# 3812 - Addendum 1

To	Kristen Haskell	Date	10/03/25
For	Long Creek Youth Development Center Ceiling Replacement	Project No.	BGS# 3812 SMRT# 25014

This addendum forms a part of the bidding and contract documents.

EFFICIENCY MAINE ELIGIBLE:  
E1: MEDIUM SECURITY 2x4 LIGHT. BASIS OF DESIGN: FAIL SAFE MODEL (COOPER LIGHTING) FMR-D-24-4-LD4-3-STD-40-UNV-81/B6-EDC-1-SWBR-SF3-PF24-4FT.

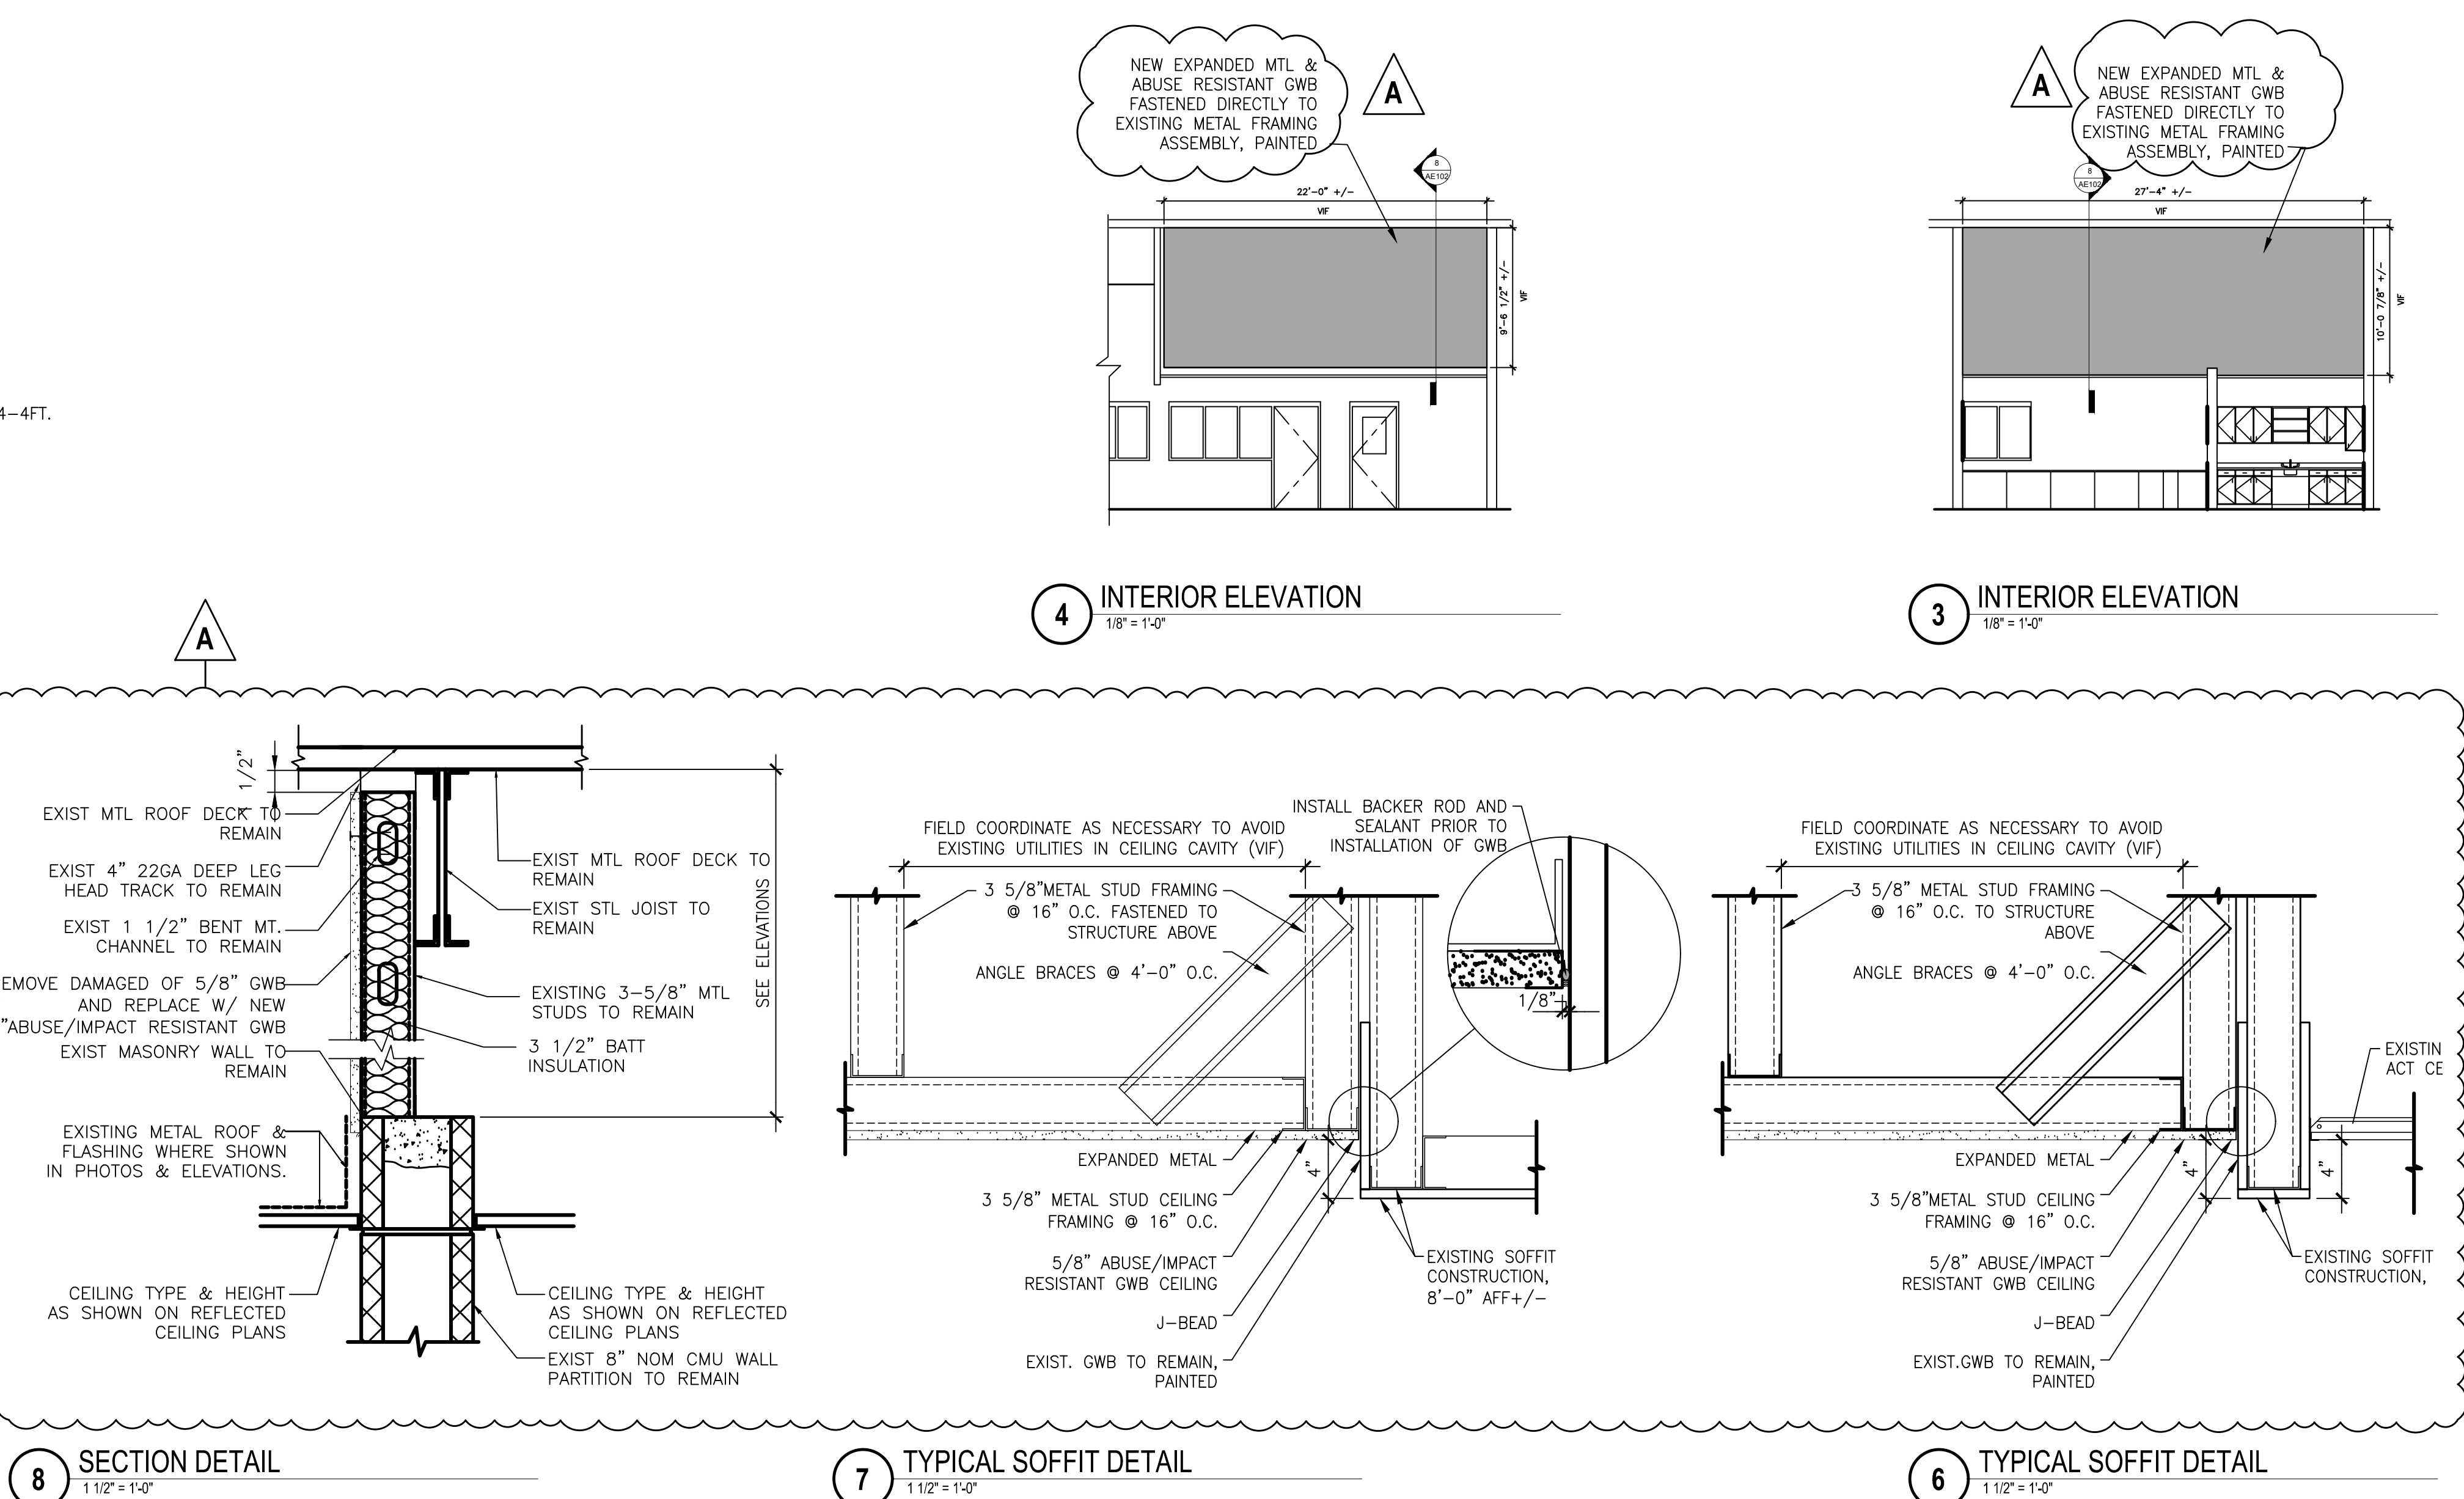
BIDDER QUESTIONS	
Q1.	Is the impact face is needed. There typically isn't a need for this type of face on the ceiling. RESPONSE: <b>Yes, the impact face is necessary.</b>
Q2.	AD102 existing pictures didn't come through on the plans? RESPONSE: <b>Refer to the attached revised drawing AD102 for photos.</b>
Q3.	Access panels are noted and mentioned to show minimum on plans? We don't see any shown. Is there a quantity we should carry with it being unknown? RESPONSE: <b>Provide (4) four security access panels within each housing unit, in addition to those called for on the reflected ceiling plans. Refer to added architectural note 10 on the attached revised drawing AE101 &amp; AE102.</b>

Q17.	For larger spans, please advise what the metal stud framing should be for the ceiling. Please provide a framing detail. RESPONSE: <b>Refer to specification section 092216 and the attached revised drawings AE101 &amp; AE102 for framing requirements.</b>
Q18.	Please advise what the metal stud framing for the new ceilings will be attached to and how it should be attached. Please provide a detail. RESPONSE: <b>Refer to specification section 092216 and the attached revised drawings AE101 &amp; AE102 for framing requirements.</b>
Q19.	What should be the finish height of the ceilings? RESPONSE: <b>Refer to the attached revised drawings AE101 &amp; AE102 for ceiling heights.</b>
Q20.	Please advise the height to the roof deck above the ceiling. RESPONSE: <b>Refer to architectural note 14 on the attached revised drawings AE101 and AE102 for bottom of steel roof deck height.</b>
Q21.	Are the walls in each room to be painted? If so, what paint and color? RESPONSE:

<b>No. Refer to the attached revised drawings AE101 &amp; AE102, and the attached revised specification section 099123 for paint scope clarifications.</b>
Q22.	Please confirm flooring is now included in this SOW. RESPONSE: <b>Flooring is not included in the scope of work. Any existing flooring damaged by construction activities would need to be replaced with new flooring.</b>
Q23.	Please advise what gauge metal studs should be installed. RESPONSE: <b>Refer to specification section 091116, 2.2, 1., a.</b>
Q24.	Please confirm no insulation is to be installed above the GWB ceilings. RESPONSE: <b>There's no insulation at the ceilings. Refer the drawings for required insulation locations.</b>
Q25.	Please advise who the existing fire alarm contractor is. RESPONSE: <b>Johnson Controls</b>
Q26.	Who services the existing fire suppression system? RESPONSE: <b>Johnson Controls</b>
Q27.	Can the superintendent be the SSHO & QCM? RESPONSE: <b>Yes.</b>
